LIVINGROOM S-O FASCIA

| <b>NEWMAR CORP</b><br>P.O. Box 30,<br>Nappanee, IN. 46550<br><br>UNITS: INCHES<br>TITLE BLOCK: 80D | Model:        | Sheet                                     | Drawn by: | Checked by: | Revision: ADDED FASCIA DETAIL (PCR #232612)                            | By: B. C.       |
|                                                                                                    | Title: FASCIA | I.D. # 2023\<br>DP\CAB\FASCIA\VT\<br>4369 | Date:     | Date:       | Revision: CHANGED THE VERTICAL FASCIA RETURN TO 3/8" MATERIAL ILO 1/2" | By: K. C.       |

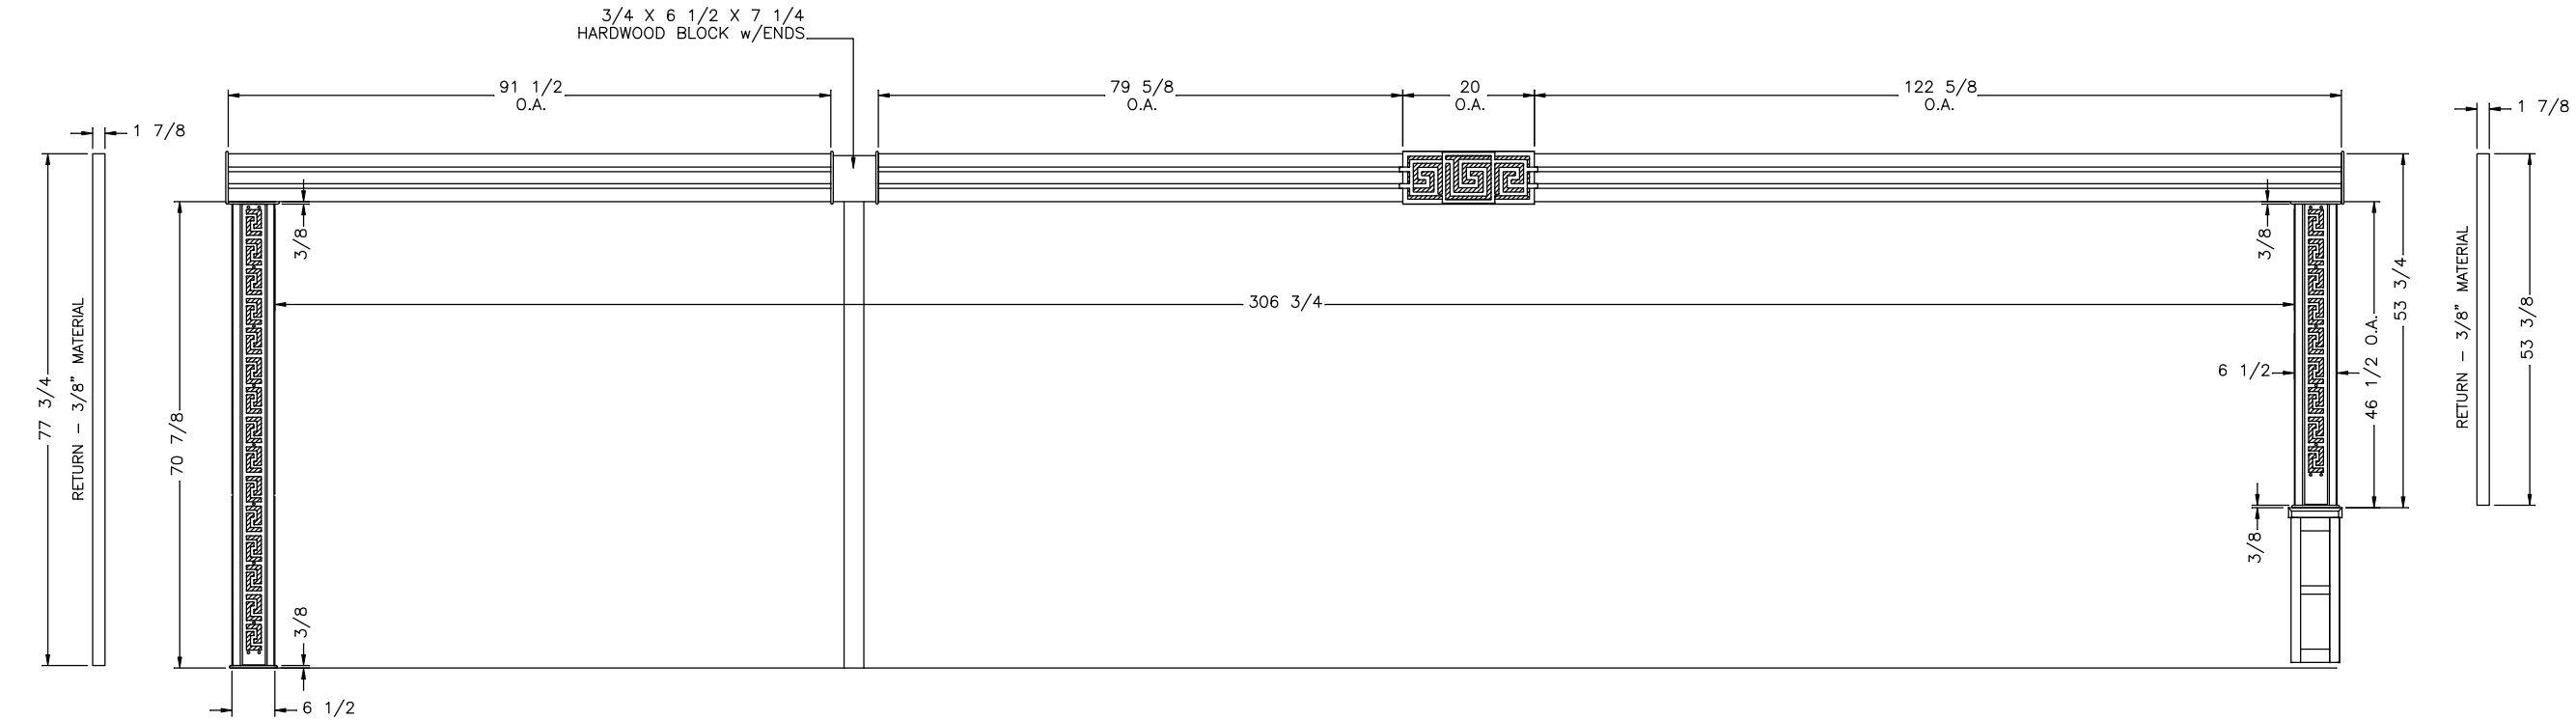
|                                                                                                    |               |                                           | 9/7/21    | 2/8/22      | MATERIAL (2023 ECO #102)                                               | Date:VK 4/26/22 |
